**MONTGOMERY COUNTY HISTORIC PRESERVATION COMMISSION**  
**STAFF REPORT**

<b>Address:</b>	30 Hesketh Street, Chevy Chase	<b>Meeting Date:</b>	4/12/2023
<b>Resource:</b>	Contributing Resource <b>Chevy Chase Village Historic District</b>	<b>Report Date:</b>	3/15/2023
<b>Applicant:</b>	Jonathan Hacker & Kristen Donogue (Henry Chuang – Agent)	<b>Public Notice:</b>	3/8/2023
<b>Review:</b>	HAWP	<b>Tax Credit:</b>	Yes
		<b>Staff:</b>	John Liebertz

**Permit Number:** 936072 REVISION

**PROPOSAL:** Amendment to a previously approved HAWP for fenestration and other alterations.

**0004**

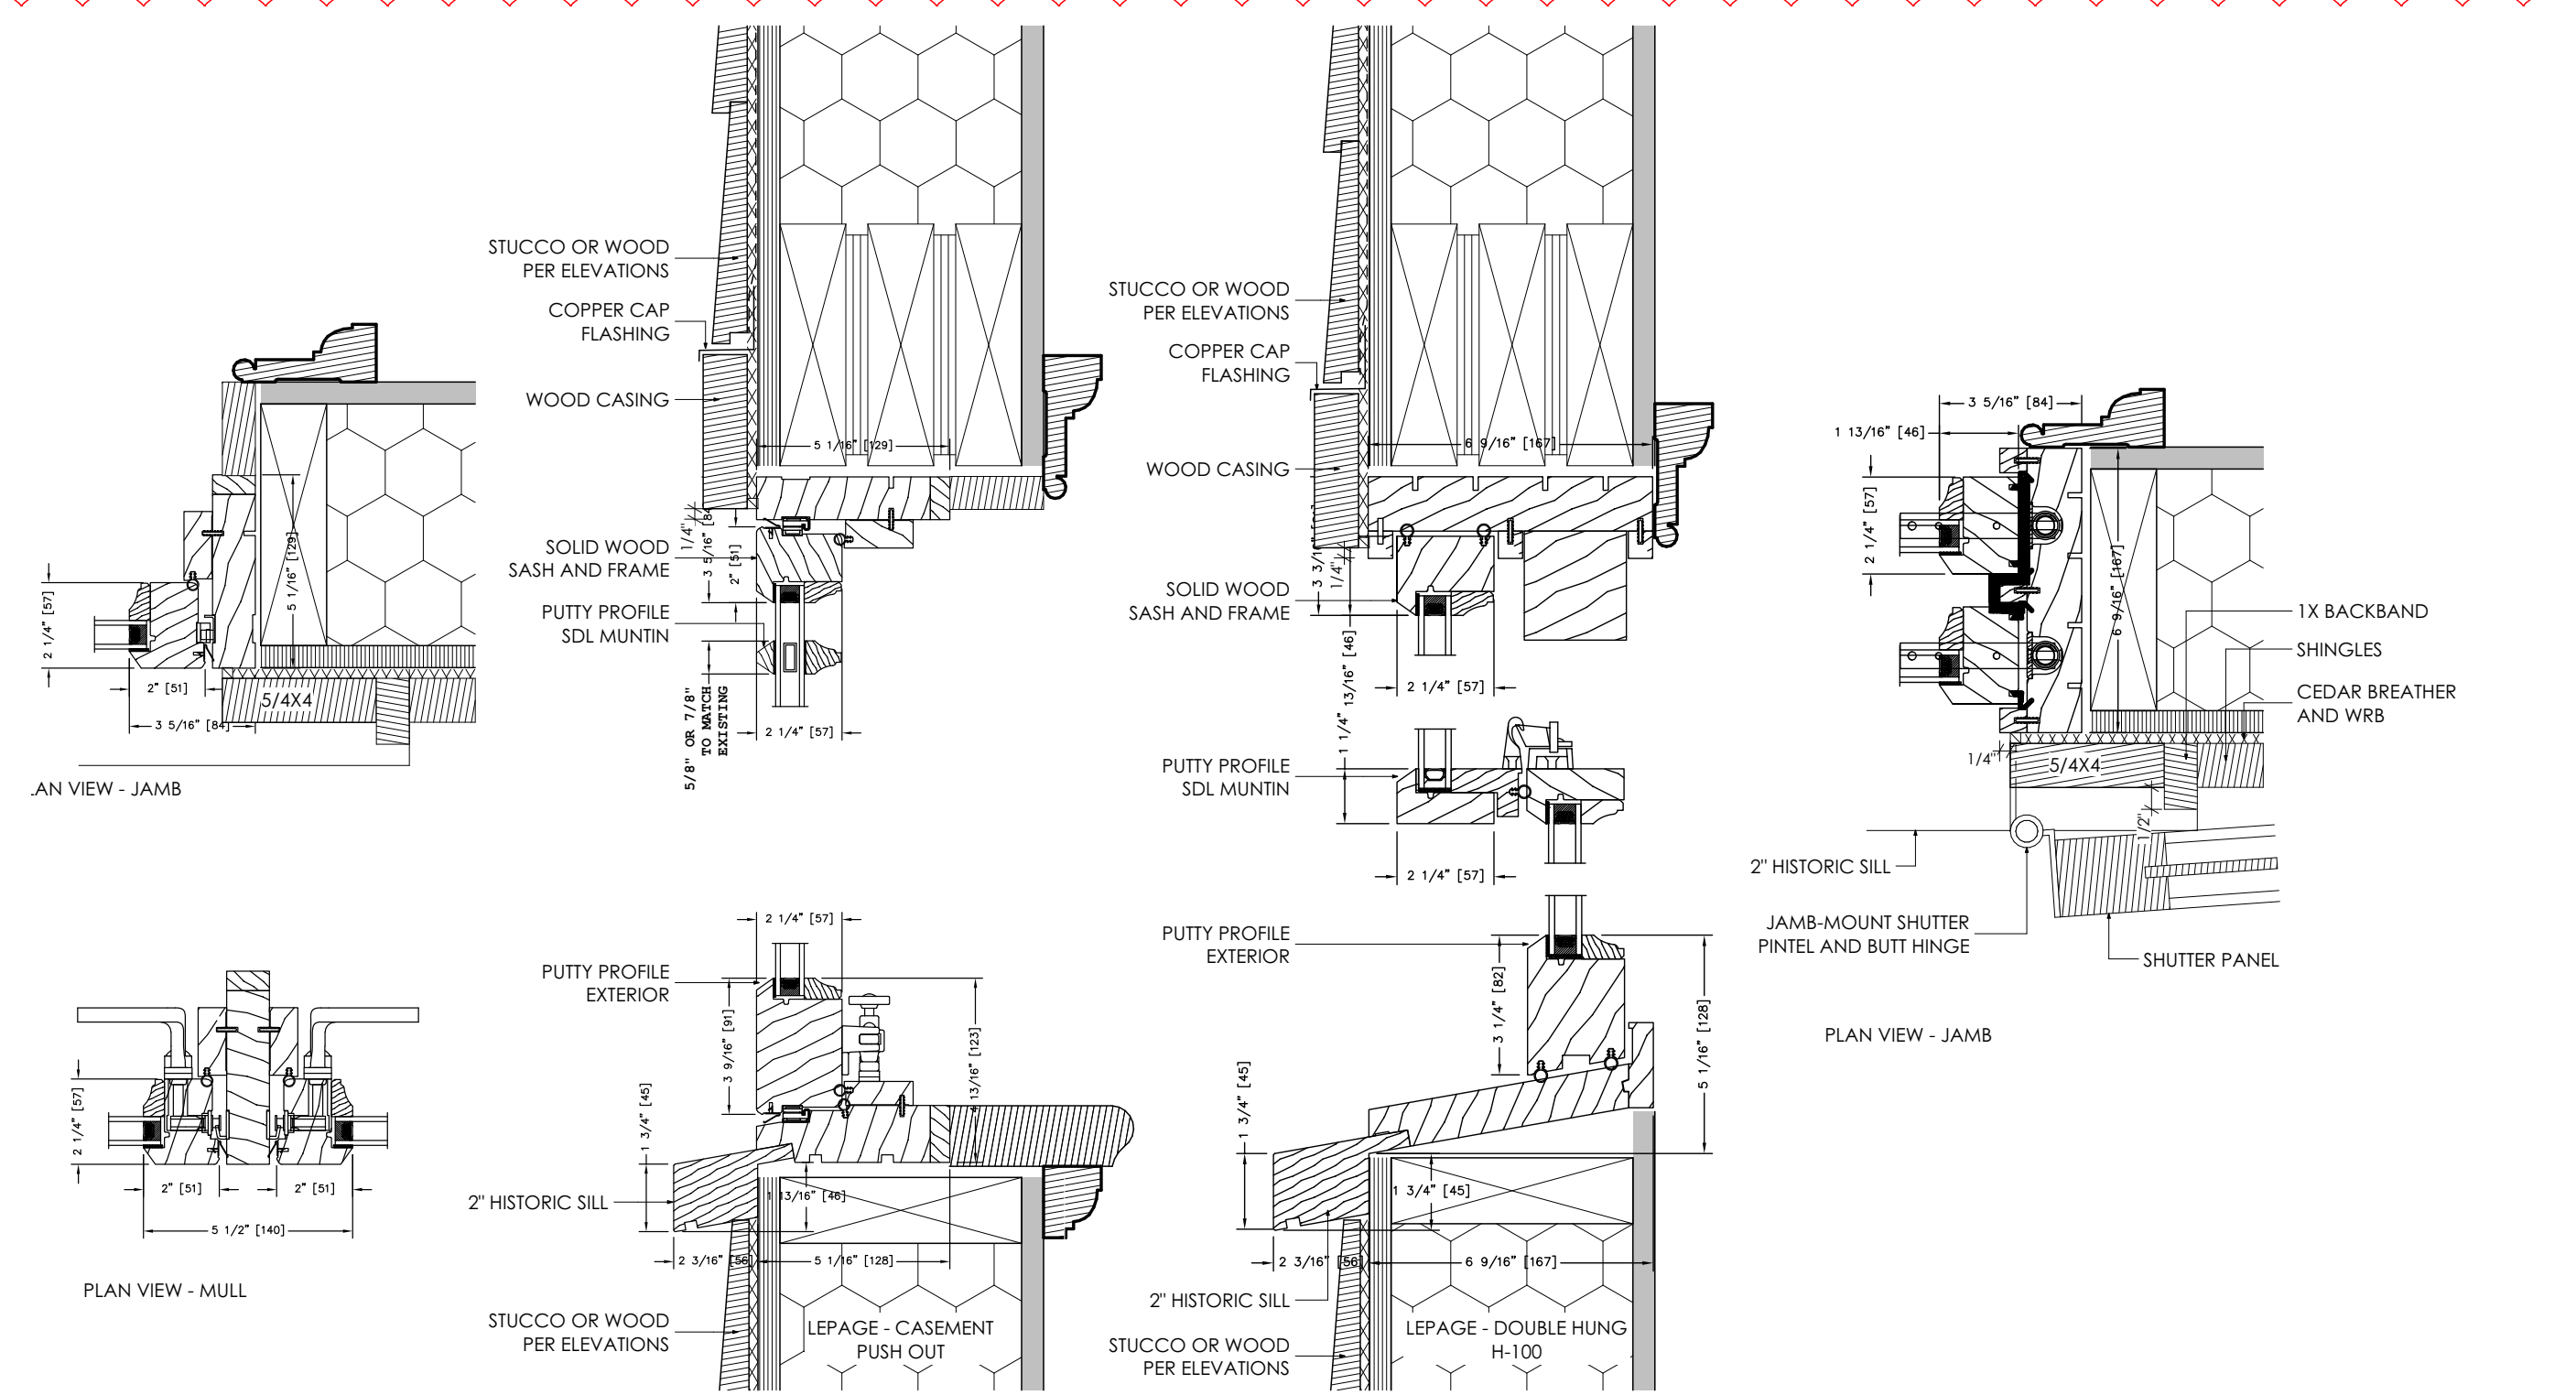
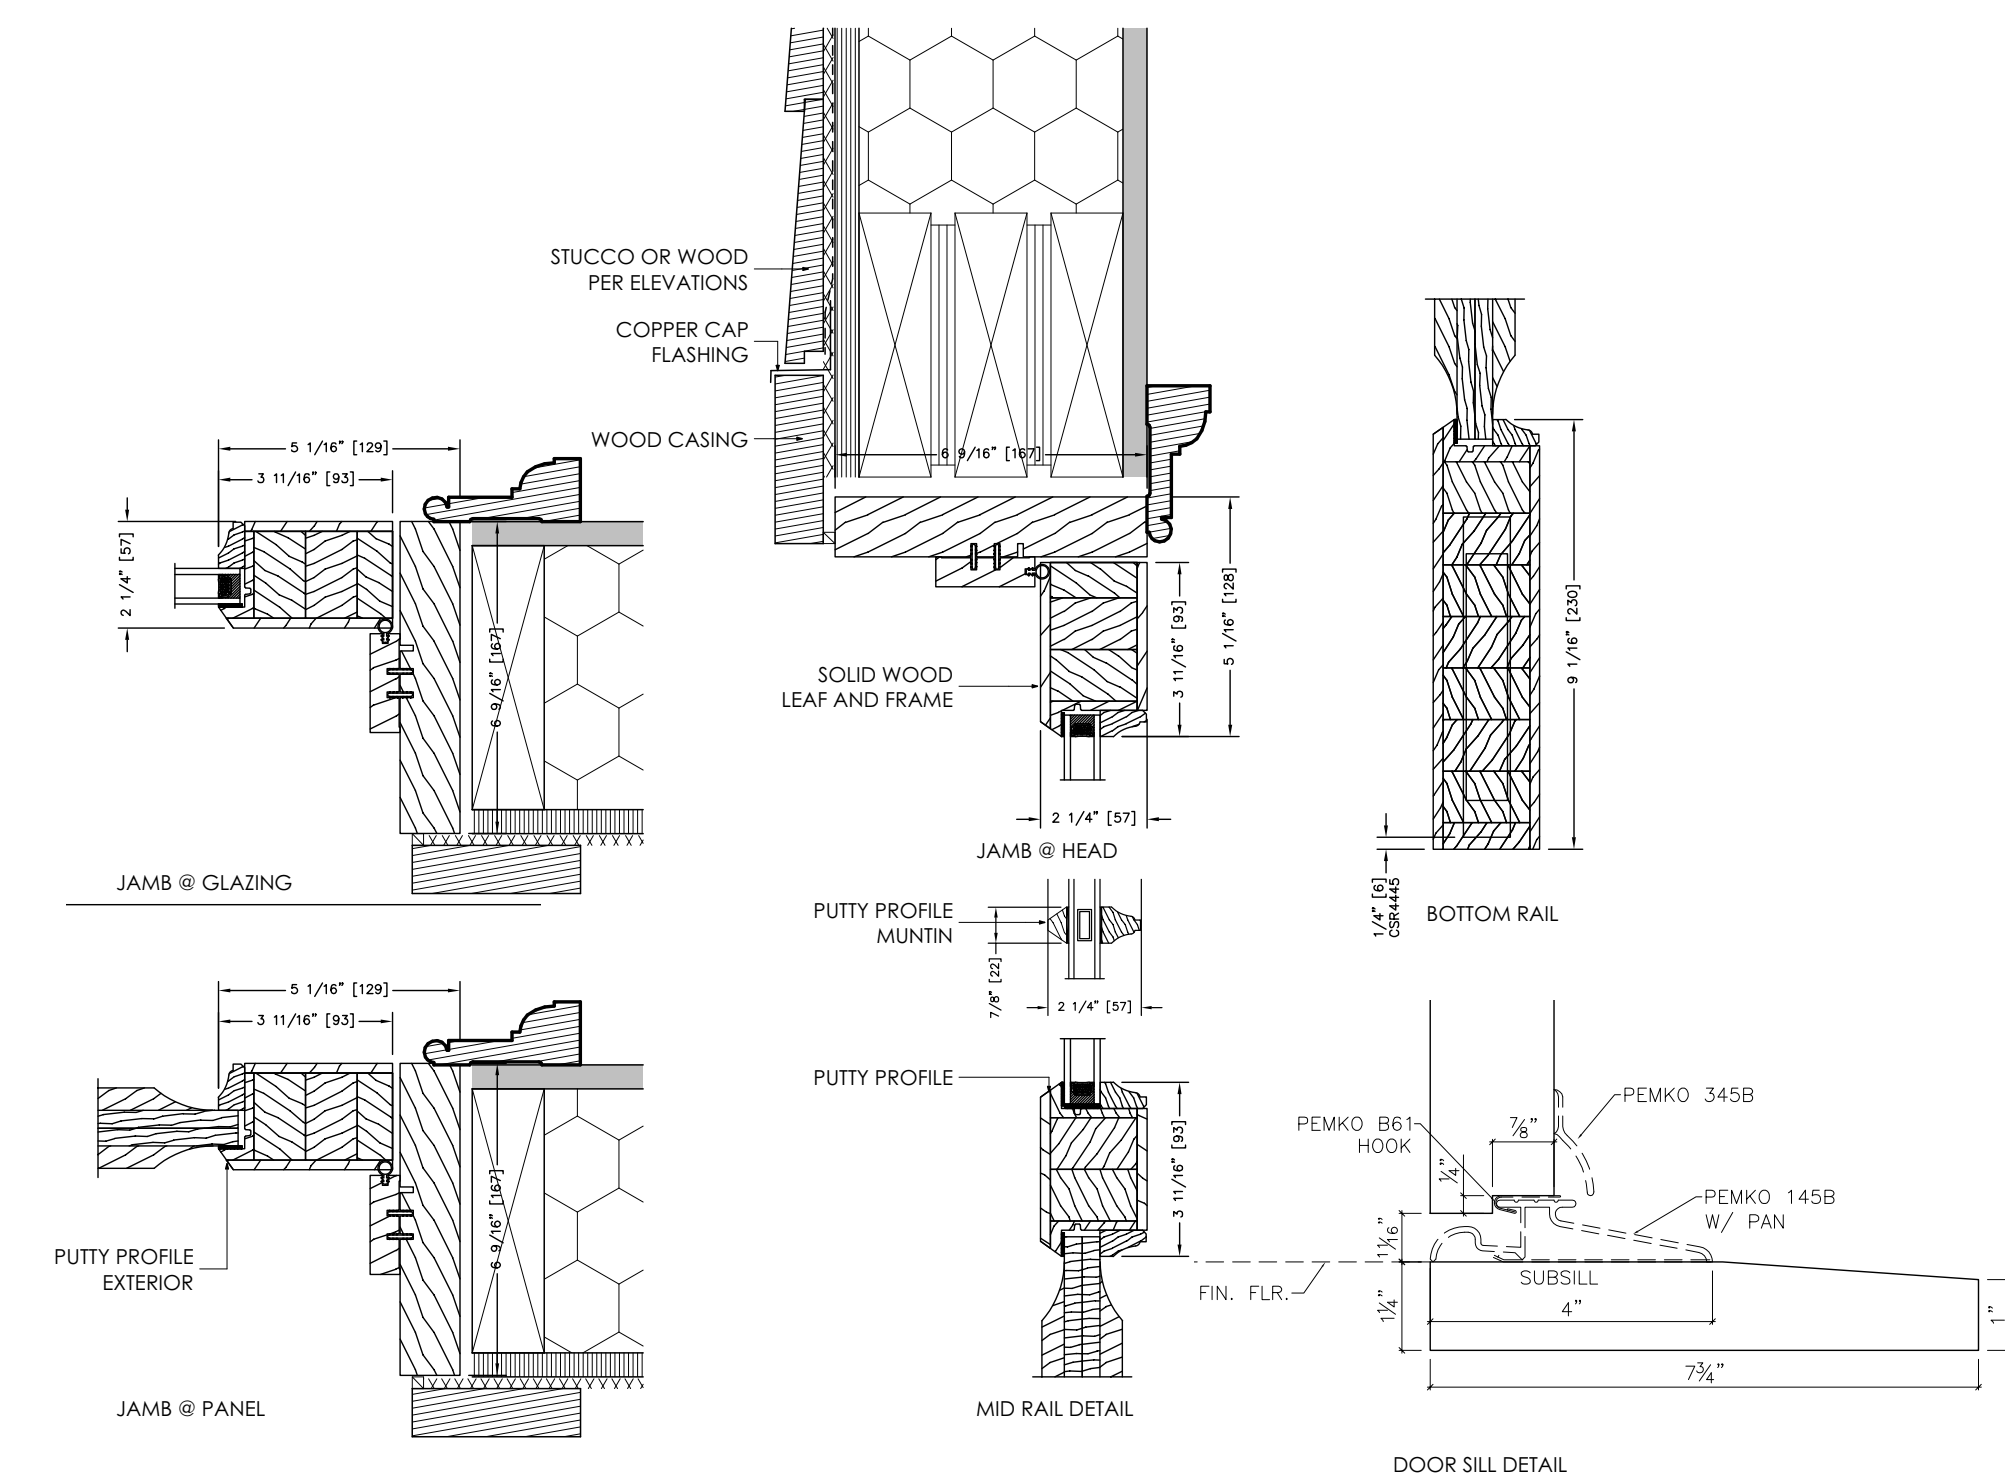
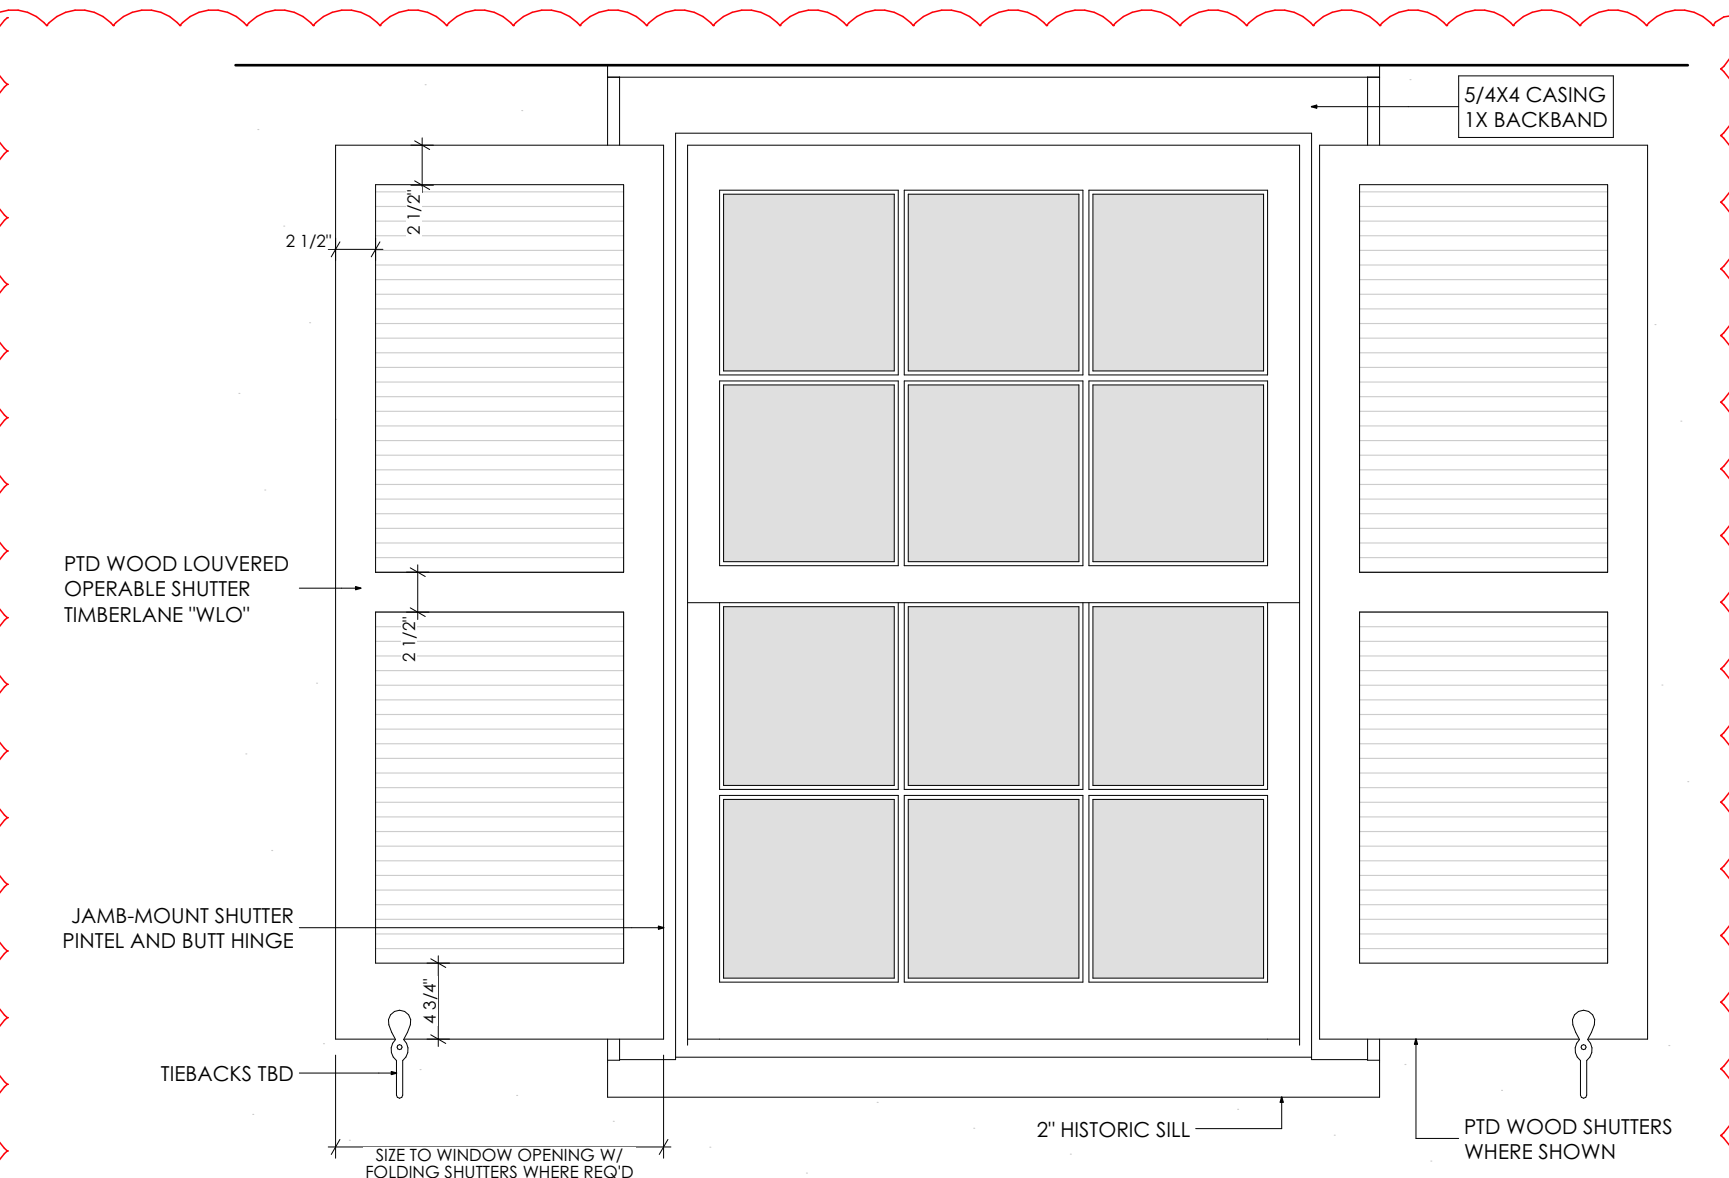
1. We would like to replace the shutters on the house. Please see sheet 0004 for details.
2. These shutters will be operable and sized to cover the entire window opening. Folding shutters will be used where required.
3. We would like to replace the existing driveway with cobbles. The footprint will remain unchanged. Material specification will be provided.
